Clare River (Claregalway) Flood Relief Scheme

Response to Further Information Request

Client:	Office of Public Works					
Project Title:	Clare River (Claregalway) Flood Relief Scheme					
Document Title:	Response to Further Information Request					
Document No:	MGE0262RP0015					
This Document Comprises:	DCS	TOC	Text	List of Tables	List of Figures	No. of Appendices
	1	1	29	1	1	1

Plate 1: Clare River - reach downstream of Crusheeney Bridge – where the “Silt and vegetation management” proposed, showing growth on one margin whilst much of the channel is unaffected.

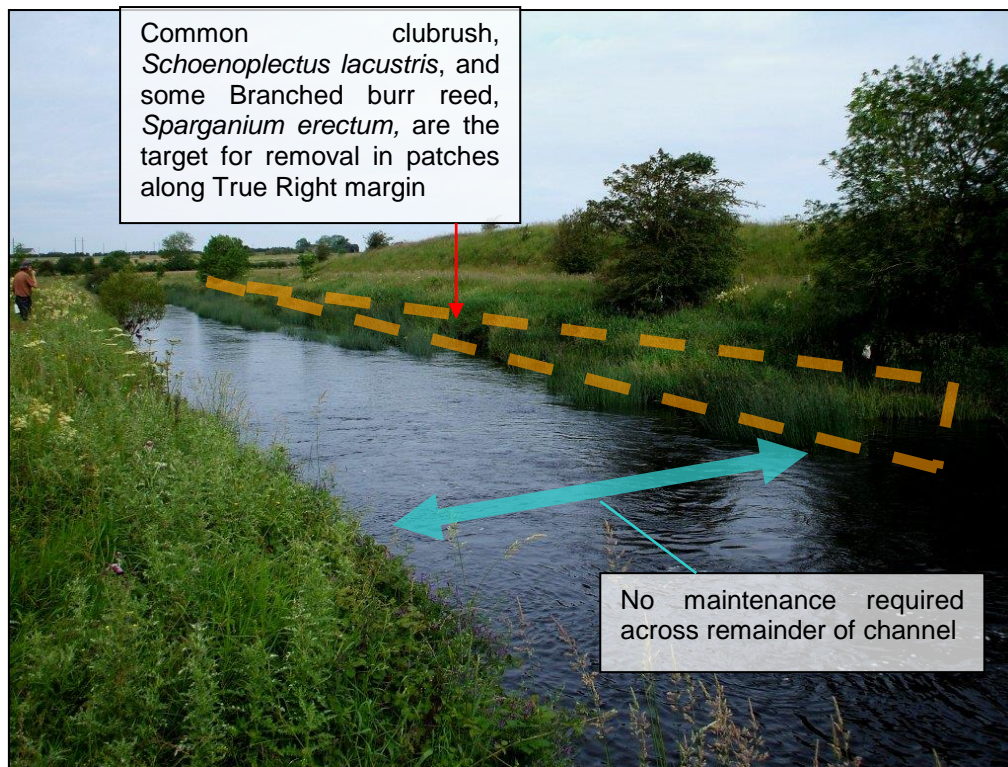
Plate 1 illustrates the reach downstream of Crusheeny Bridge where Element A is proposed targeting patches of accumulated silt and vegetation within a reach of approx. 300m linear channel length. Silt and vegetation management applies to the True Right bank/margin as shown, whilst $\frac{2}{3}$ to $\frac{3}{4}$ of the channel is open water. This reach was observed during field studies to have the greatest extent of this type of instream marginal emergent growth of any reach that is earmarked for Element A. Other areas earmarked for silt and vegetation management with this type of marginal emergent growth have less dense and extensive instream growth affecting small patches of the overall reach earmarked. Plate 2 illustrates a typical example of this, where only a small patch on an inside river bend is targeted.

Plate 3: Clare River - reach between Islandmore and Grange West – a short reach where “Silt and vegetation management” is proposed in relation to Reed canary grass on one margin

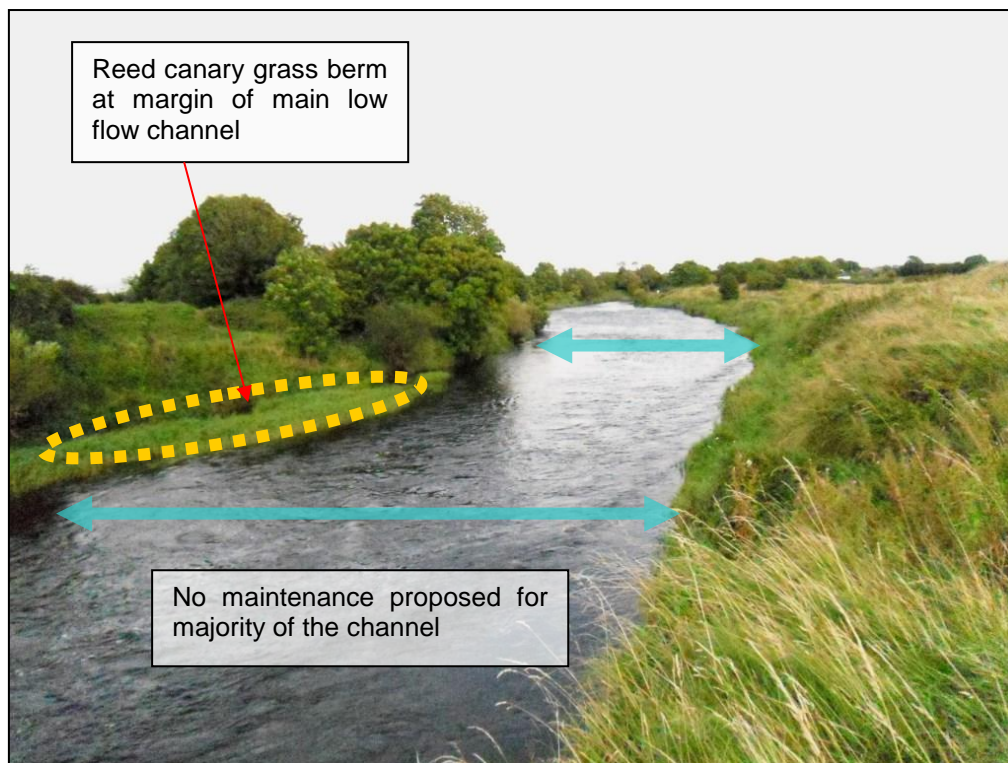
Plate 3 illustrates the nature of the Clare River between Islandmore confluence and Grange West (Cregmore Bridge). The river is fast flowing and does not favour silt accumulation and vegetation growth in the main, apart from in small pockets where Reed canary grass (*Phalaris arundinacea*) tends to form vegetated berms under such conditions. This hydromorphological feature signifies a self-narrowing of the river corridor where the edge of the berm defines the typical low flow channel. A short stretch is earmarked in this reach for Elements A and B. OPWs maintenance approach in such cases is to top the berm only. This protects the low flow channel and leaves some embedded silt and *Phalaris* roots. The rest of the channel remains untouched; hence the magnitude and scale of Elements A and B can be seen to be low in this reach. *Phalaris* tends to grow back quite rapidly atop the slightly lowered berm which can increase channel capacity without affecting the low flow channel and aquatic, especially fisheries, values.
